**LEBANON PLANNING BOARD
OCTOBER 12, 2021 - 6:30 PM
COUNCIL CHAMBERS, CITY HALL OR
REMOTE VIA VIRTUAL PLATFORM
LEBANONNH.GOV/LIVE**

**Mason Storage, LLC,
38 Spencer Street
(Tax Map 78, Lot 39),
Zoned LD
PB2021-13-SPR**

Staff Memorandum – PB2021-13-SPR – *continued from 9/13/21*

Re: Site Plan Lot 78-39
38 Spencer Street

EROSION CONTROL PLAN

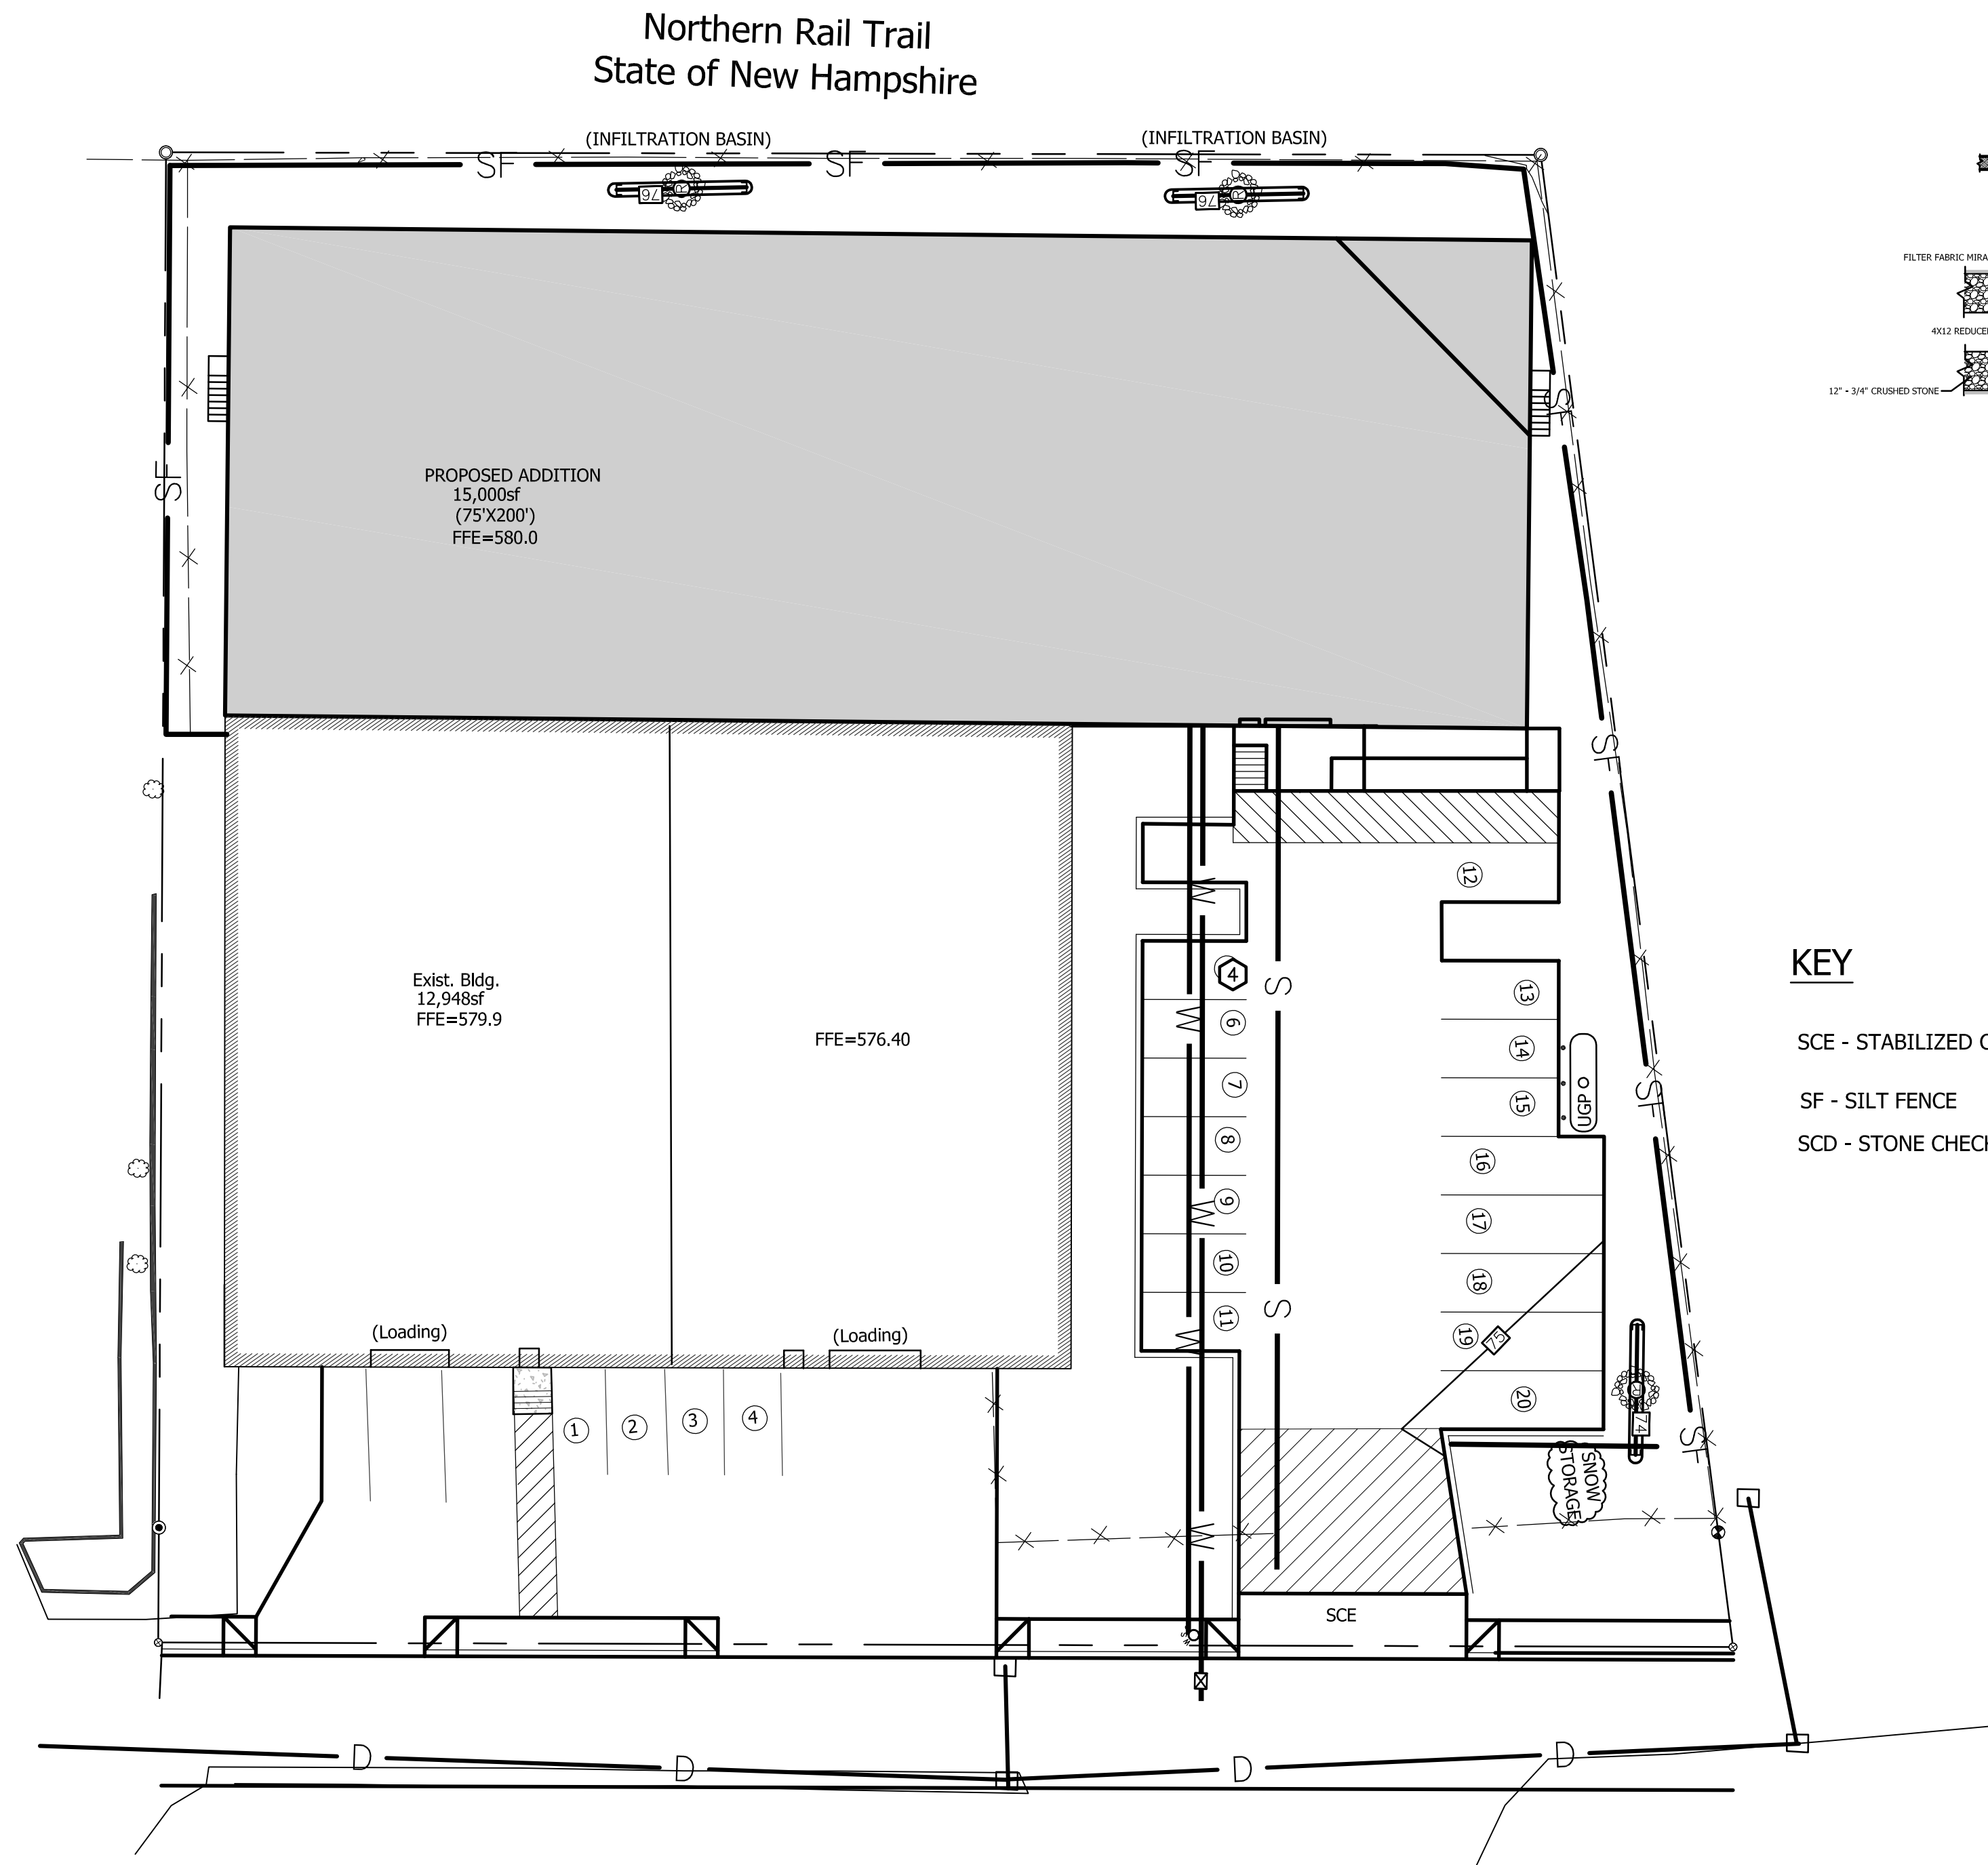
- Given the building configuration, equipment access to the south of the building will likely be difficult. Consequently, the Department of Public Works recommends that, prior to making a determination on the site plan, the applicant should demonstrate to the Planning Board that the proposed building/building foundation can be constructed without impacting the abutting properties.
- The Applicant should further demonstrate that the proposed infiltration practice construction detail, shown on Sheet C-3, provides a minimum of 1 foot vertical separation from estimated

seasonal high water table (SHWT). In addition, the drainage report should address saturated hydraulic conductivity of the existing receiving soils, and include stormwater modeling of each proposed infiltration practice. Finally, the drainage report should include a discussion of the proposed vegetative filter strips, and the plans should also show or articulate the locations, lengths, and grading of these proposed pre-treatment practices. The proposed infiltration practices may require re-sizing depending on the actual saturated hydraulic conductivity of the receiving soils. Given that the overall stormwater runoff is reduced off of the site in the proposed conditions, these above-described stormwater management and treatment details may be addressed as a condition of approval.

Item 12. An erosion control detail sheet has been added.
